**Sundry ID:** 2795590

**Type of Action:** Plug and Abandonment

**MCMANUS 10****30.045.05564****PLUG AND ABANDONMENT**

Subject: [EXTERNAL] P&A Revision Request for Hilcorp's MCMANUS 10 (API # 3004505564)

Current Schematic - Version 3

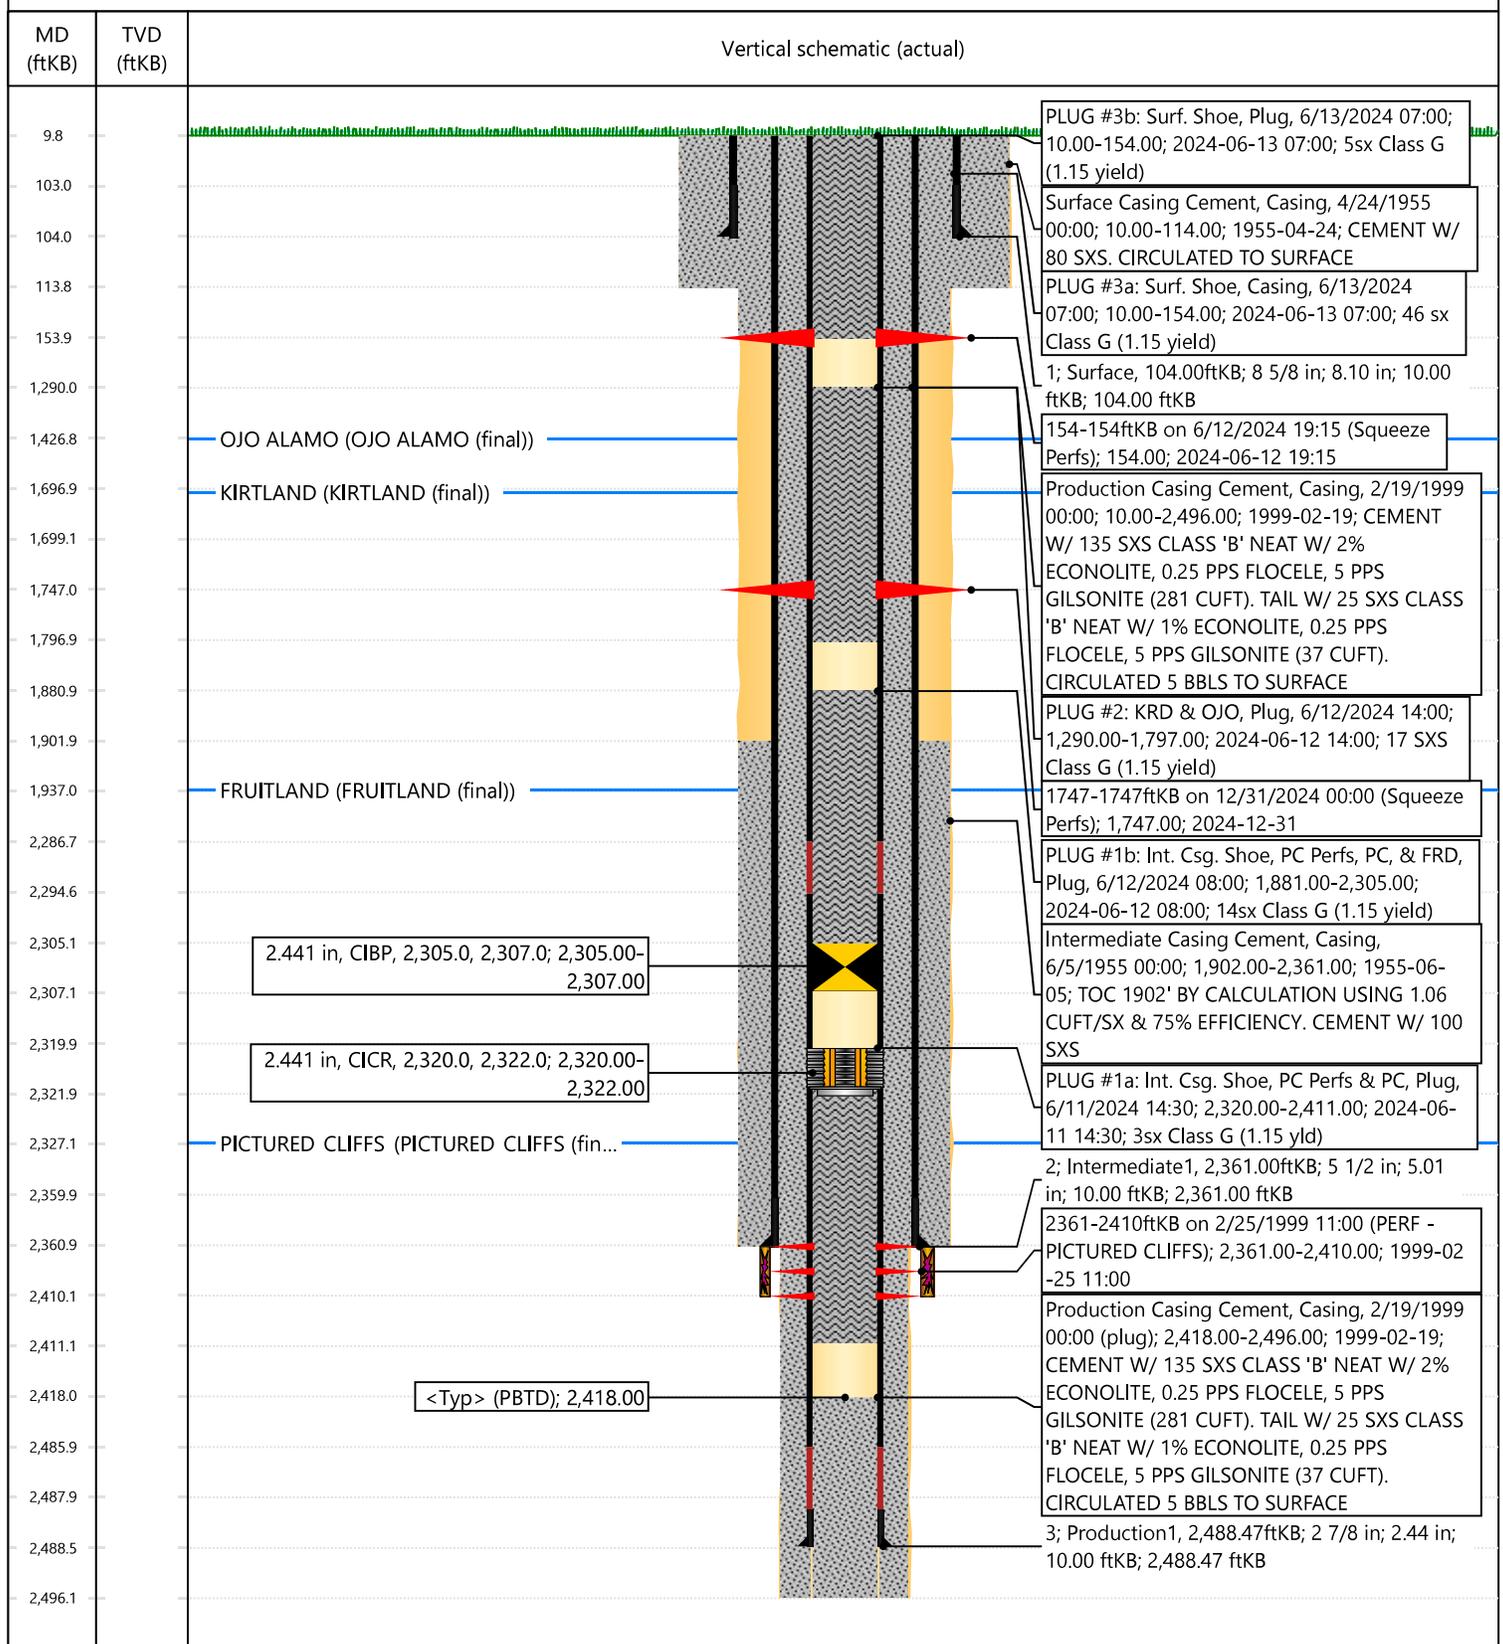
Today we successfully pumped Plug #1b, WOC, and tagged Plug #1b. We then proceeded to perforate @ ~1,747 per the approved revision below (~50' below the KRD top). We then attempted to establish injection but were unsuccessful. The well pressured up to 970 psi with no injection rate.

Hilcorp received verbal approval from the NMOCD and BLM to forego pumping the outside plug, and just pump the inside plug for the KRD & OJO, with an estimated BOC @ 1,797' (50' below the perfs @ 1,747') and an estimated TOC @ 1,327'.

Per our conversation, we successfully set the 2-7/8" CICR @ 2,320' and pumped Plug #1a. We then attempted to set the 2-7/8" CIBP @ 2,311' but tagged at 2,305'. Hilcorp then received verbal approval from the NMOCD and BLM to set the CIBP @ 2,305'.

- PLUG #1a: The CICR will be set at 2,320' (Int. Surface Shoe @ 2,361', PC Perfs @ 2,361', PC Top @ 2,327'). (NMOCD provided verbal approval for this after discussing the depths compared to the original COAs)
  - Pump 91' of cement beneath the CICR from 2,320' to 2,411' (50' beneath the intermediate shoe).
- PLUG #1b: The CIBP will be set at 2,311' (Int. Surface Shoe @ 2,361', PC Perfs @ 2,361', PC Top @ 2,327', FRD Top @ 1,937') as stated in the original NOI. (NMOCD provided verbal approval for this after discussing the depths compared to the original COAs)
  - Pump 474' of cement on top of the CIBP from 1,837' to 2,311'.
- All other plugs have been adjusted according to the BLM & NMOCD formation tops. Please see the revised procedure attached and below.

3. MIRU service rig and associated equipment; NU and test BOP.
4. Set a 2-7/8" CICR at +/- 2,320' to isolate the PC Perfs.
5. **PLUG #1a: 3sx of Class G Cement (15.8 PPG, 1.15 yield); Int. Casing Shoe @ 2,361' | PC Perfs @ 2,361' | PC Top @ 2,327':**  
Pump a 3 sack cement plug beneath the 2-7/8" CICR inside the 2-7/8" casing (est. **TOC @ +/- 2,320'** & est. **BOC @ +/- 2,411'**).

9. **PLUG #1b: 14sx of Class G Cement (15.8 PPG, 1.15 yield); Int. Casing Shoe @ 2,361' | PC Perfs @ 2,361' | PC Top @ 2,327' | FRD Top @ 1,937':**  
Pump a 14 sack balanced cement plug inside the 2-7/8" casing (est. **TOC @ +/- 1,837'** & est. **BOC @ +/- 2,311'**).

10. POOH w/ work string. TIH & perforate squeeze holes @ +/- 1,747'. RIH w/ 2-7/8" CICR and set CICR @ +/- 1,697'. TIH w/ work string & sting into CICR. Establish injection.

11. **PLUG #2: 84sx of Class G Cement (15.8 PPG, 1.15 yield); KRD Top @ 1,697' | OJO Top @ 1,427':**  
Pump 71sx of cement in the 5-1/2" casing X 7-7/8" open hole annulus (est. **TOC @ +/- 1,277'** & est. **BOC @ +/- 1,747'**). Pump an additional 2sx of cement beneath the 2-7/8" CICR (est. **TOC @ +/- 1,697'** & est. **BOC @ +/- 1,747'**). Sting out of retainer, pump a 11 sack balanced cement plug on top of the CICR. (est. **TOC @ 1,327'** & est. **BOC @ +/- 1,697'**). WOC for 4 hrs, tag WOC w/ work string. \*Note cement plug lengths and volumes account for excess.

12. POOH w/ work string. TIH & perforate squeeze holes @ +/- 154'. Establish circulation.
13. **PLUG #3: 31sx of Class G Cement (15.8 PPG, 1.15 yield); Surf. Casing Shoe @ 104':**  
Pump 8sx of cement in the 5-1/2" casing X 7-7/8" open hole annulus (est. **TOC @ +/- 104'** & est. **BOC @ +/- 154'**). Continue pumping 18sx of cement in the 8-5/8" casing X 5-1/2" casing annulus (est. **TOC @ +/- 0'** & est. **BOC @ +/- 104'**). Pump a 5 sack balanced cement plug inside the 2-7/8" casing (est. **TOC @ +/- 0'** & **BOC @ +/- 154'**). WOC for 4 hrs, tag WOC w/ work string.
